Access Compliance Report Public Rights-of-Way (Curb Ramps)

Main Street: ERVIN_LN Cross Street: JUDY_ANN_LN Location: NW

ADA ID: RPAT211005151600 Ramp Type: Type 1 - Perpendicular Diagonal Initial Pass/Fail: Fail Overall Compliance: No Severity Score: 5

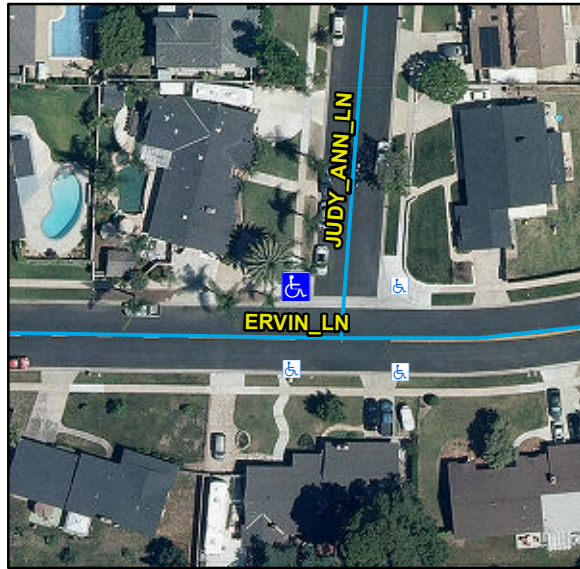
Remove & Replace Curb Ramp With Two New Directional Ramps or Equivalent.
